PRE-BID CLARIFICATION FORM

PROJECT NAME:	FILLMORE HIGH SCHOOL NEW ATHLETIC COMPLEX		
PROJECT NUMBER:	Project No. 2024-017 / DSA #03-123950		
TO:	RJ Stump Fillmore Unified School Dist. Roy Frey WestGroup Designs		
	EMAIL: ri.stump@fillmoreusd.org , EMAIL: royf@westgroupdesigns.com		
DATE:	2.5.2025		
FROM:	S.C. Anderson, Inc.	EMAIL:	estimating@scanderson.com joejannino@scanderson.com ramosr@scanderson.com
DOCUMENT/DIVISION NUMBER:	05 12 13	DRAWING NUMBER:

SHEET TITLE:
LOW ROOF FRAMING PLAN

LOW ROOF FRAMING PLAN

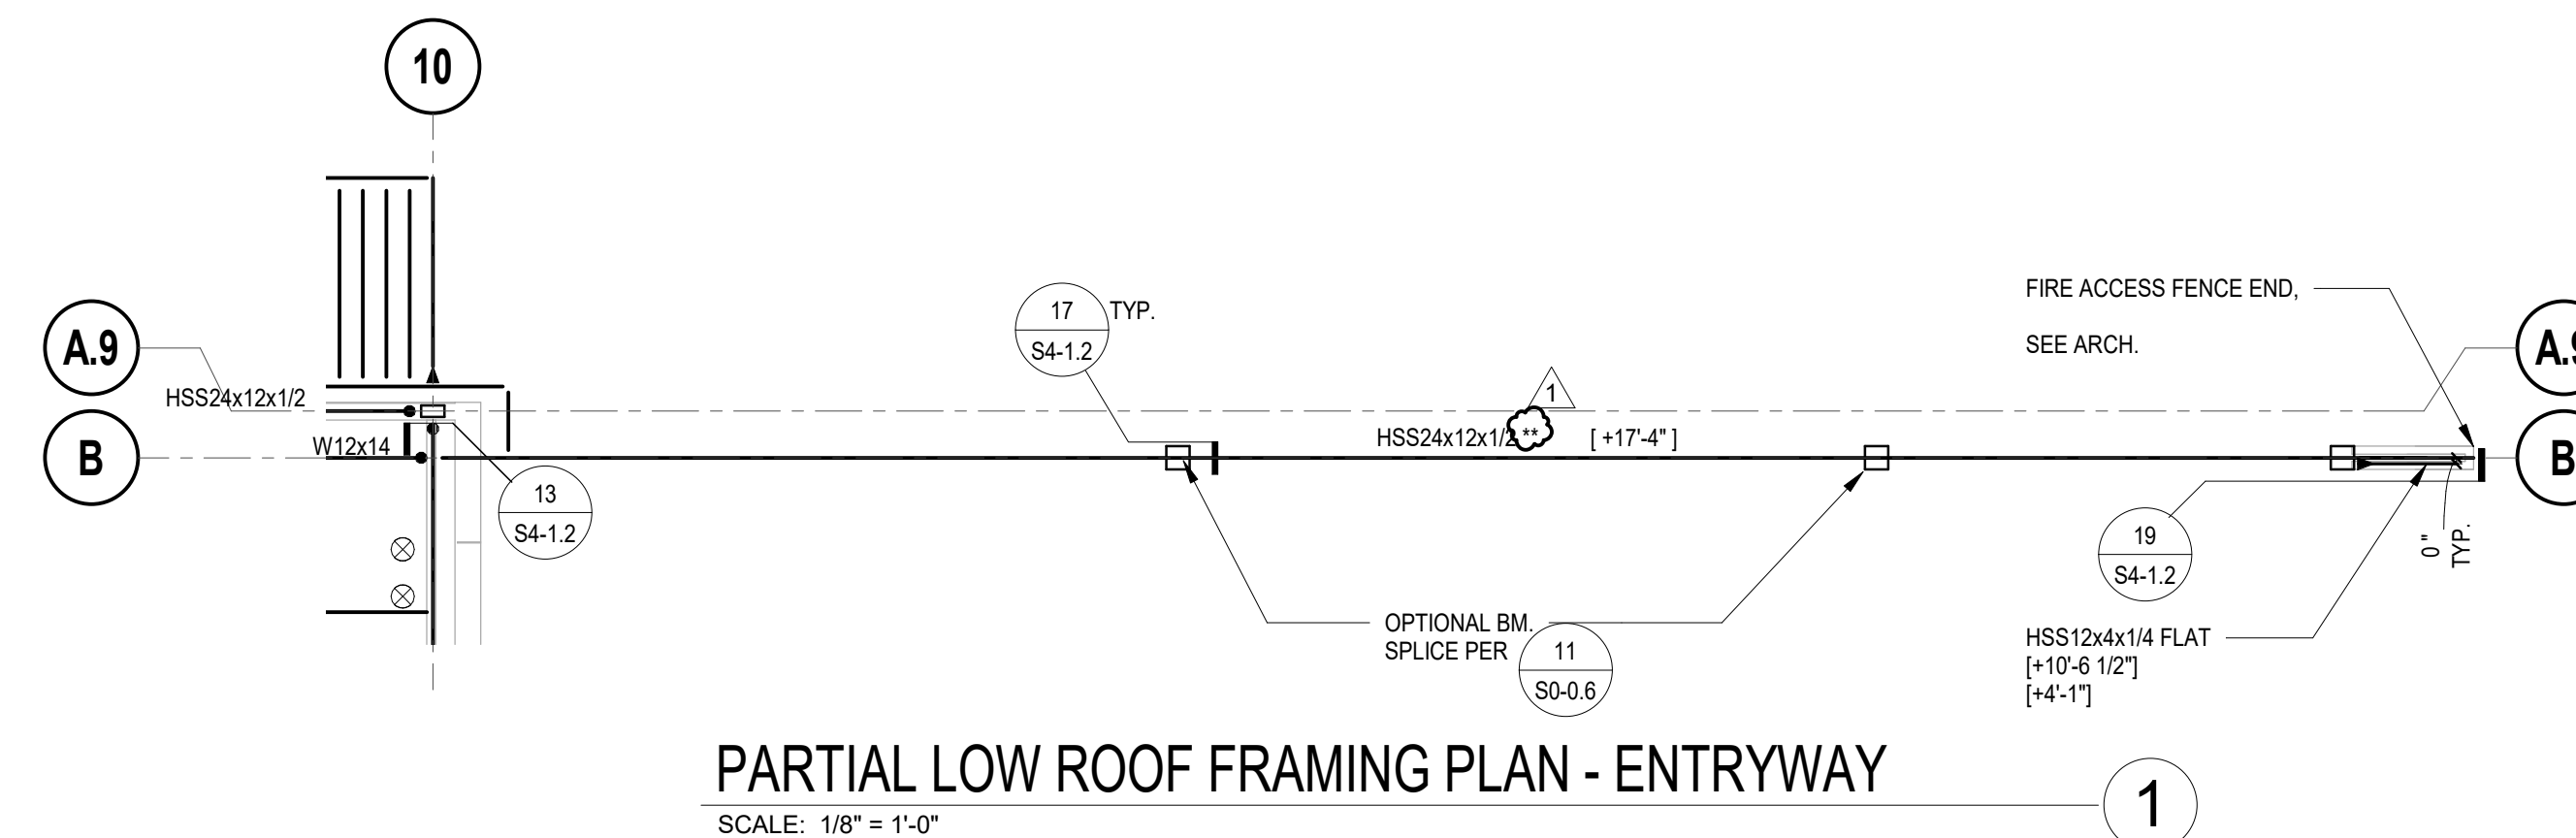
Spec section 05 12 13 - Architecturally Exposed Structural Steel (AESS) Framing is included in the specs, but neither the Architectural nor Structural drawings indicate any AESS steel. AISC clearly states that steel members designated as AESS must be identified on the drawings. Given this, does this specification apply to this project. If so, please clarify on the plans where it applies.

AESS marked on structural plans. Level to be AESS 3. See revised drawings.
